# Access Compliance Report

## Public Rights-of-Way

Intersection ID: 11189	Main Street: MENDHAM_DR	Cross Street: MILTON_RD	Location: NE
ADA ID: C7221CAA439D	Ramp Type: PerpDiag	Initial Pass/Fail: Fail	Overall Compliance: No
		Severity Score: 60

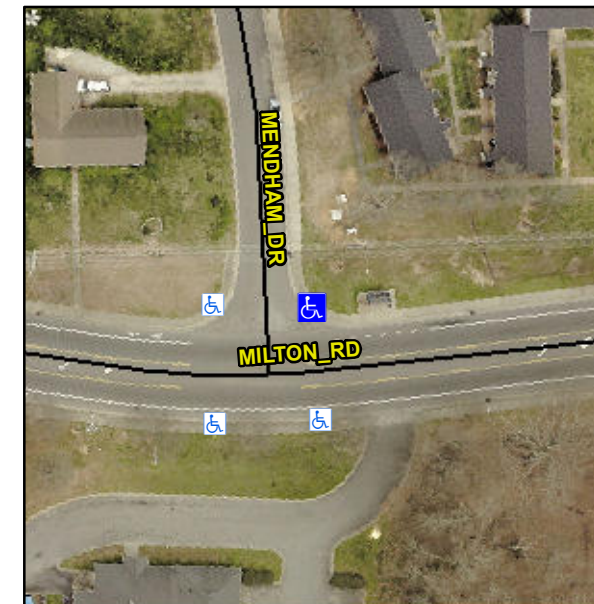
**Not Found, R304.5.1, R304.2.2**

Compliance	Description	Data	Compliance	Description	Data
N/A	Ramp Length (in)	60.0	No	Ramp Slope (%)	12.8
No	Ramp Width (in)	31.5	Yes	Ramp XSlope (%)	0.4
N/A	Flare Type LT	N/A	N/A	Flare Type RT	N/A
N/A	Flare Slope LT (%)	N/A	N/A	Flare Slope RT (%)	N/A
N/A	Flare Traversable LT?	N/A	N/A	Flare Traversable RT?	N/A
N/A	Landing Length (in)	N/A	N/A	DWS Provided?	N/A
N/A	Landing Width (in)	N/A	N/A	DWS Contrast?	N/A
N/A	Landing Slope (%)	N/A	N/A	DWS Length (in)	N/A
N/A	Landing X Slope (%)	N/A	N/A	DWS Full Width?	N/A
N/A	Landing Curb? (Y/N)	N/A	N/A	DWS Offset (in)	N/A
N/A	Shared Landing?	N/A			
N/A	Gutter Ponding?	N/A	N/A	Gutter Slope (%)	N/A
N/A	Gutter Lip Ht (in)	1.0	N/A	Gutter X Slope (%)	N/A
N/A	Painted X Walk1?	No	N/A	Painted X Walk2?	No
	X Walk 1 Direction	To W		X Walk 2 Direction	To S
N/A	X Walk 1 Width (in)	N/A	N/A	X Walk 2 Width (in)	N/A
	X Walk 1 Slope (%)	0.9		X Walk 2 Slope (%)	3.6
	X Walk 1 X Slope (%)	1.3		X Walk 2 X Slope (%)	0.0

**Remove & Replace Curb Ramp With Two New Directional Ramps or Equivalent.**
